#### HISTORIC AND DESIGN REVIEW COMMISSION

**HDRC CASE NO:** 2022-527

**ADDRESS:** 108 SCHREINER PLACE

**TYPE OF WORK:** Construction of a carport

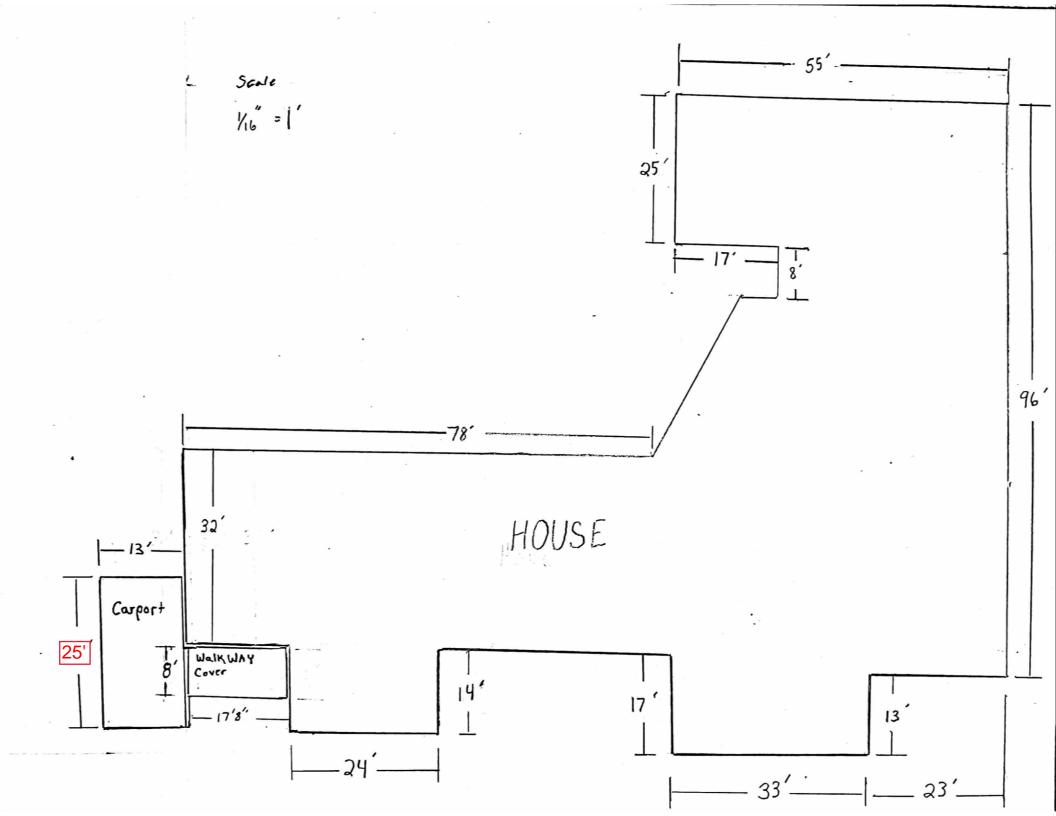
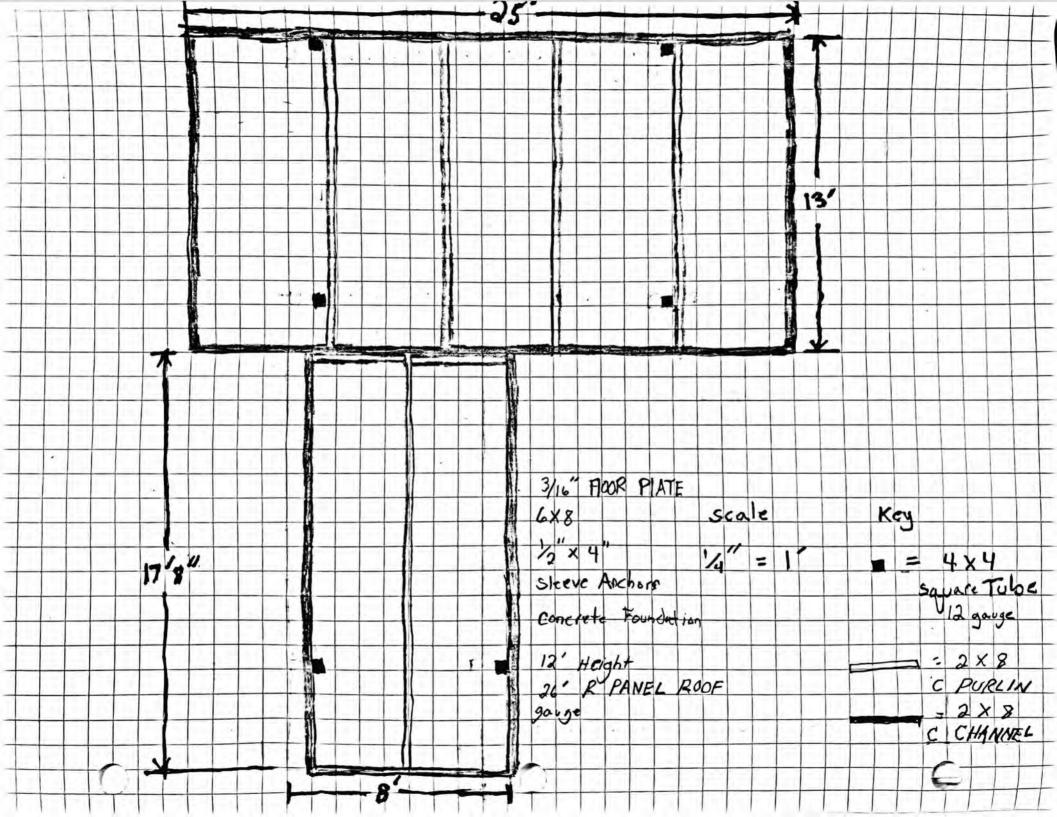
Cervantes: Is the carport touching the roof?

Savino: In terms of modifying the existing design, you could drop the height of the passageway and use a thinner profile metal for the beam.

Russell: The size and materials of the carport help it withstand the wind.

Garza: I agree regarding lowering the walkway height.

Owner and/or contractor should reach out to Development Services regarding setback requirements for the property. Applicant should explore lowering the overall height of the carport, with particular attention to the passageway.
